RE: HP Hood

HP Hood Pilecap

Subject: FW: Sugar tank dimensions and info

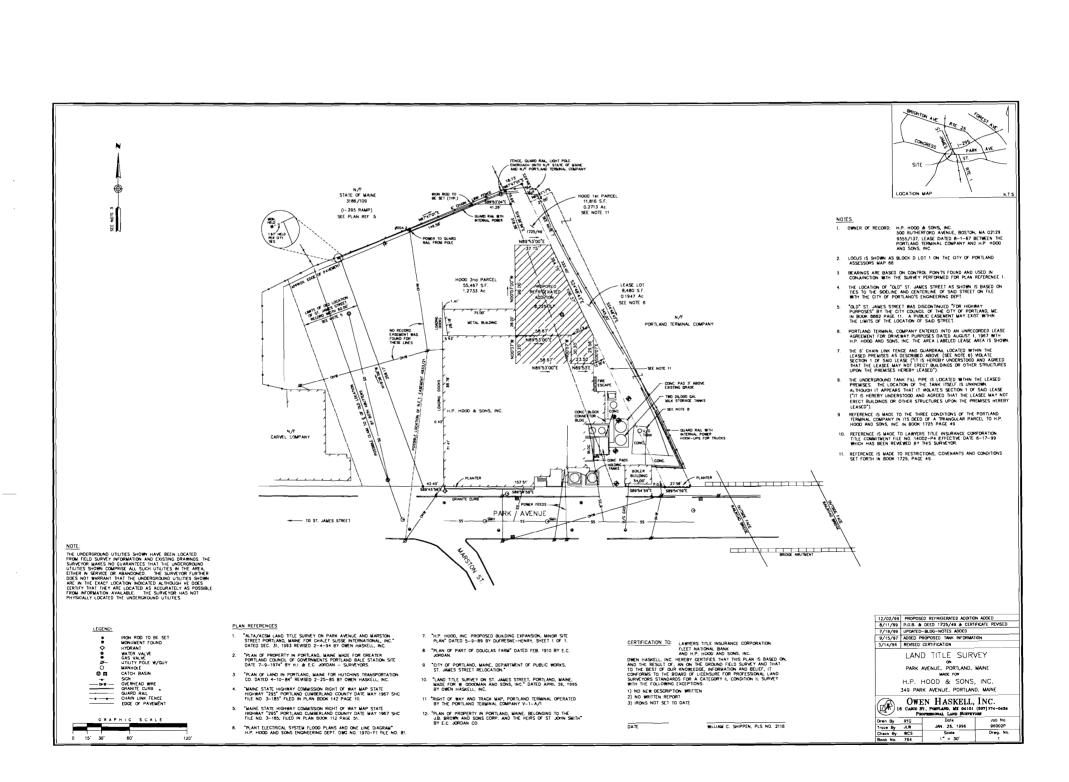
I did receive the plan this morning. I also was able to find a the full scale plan from the permit in 1999. I do have a couple of questions for you. The original plan you submmitted showed the concrete

pad as 5'4" frpom the property line. The side setback in the IM zone says that the structure must be setback one foot for each foot of building height up to 25'. I need to know how high the sugar tank is going to be. I also need to have plans that show the dimensions of the

tank. The 1996 survey you sent me, shows the property line for the "1st

parcel" and then it shows the lines for the "lease lot". Note 6 talks about this lease as "an unrecorded lease agreement for driveway purposes

dated August 1, 1957". Is there a copy of this lease? It is referred to in some of the other notes.

Thank you Ann. The tank is a 21' high tank that sets on a 4' high skirt for a total height of 25'. The tank weight and other design criterion are identified on our S1 drawing. Other information as follows: 6,000 gallon vertical liquid sugar tank with 3'x3' skirt access door insulated and jacketed. Tank is lined with FDA/USDA plasite 7133 food grade epoxy. Thanks.

>>> "Dan Burne" <dan@beckerstructural.com> 9/26/2007 1:24:51 PM >>> Ann,
The tank dimensions are on the plot plan I sent you yesterday (7' diameter,
25' high). I will get in touch with HP Hood Regarding the Lease and let you know. Thanks.
Dan
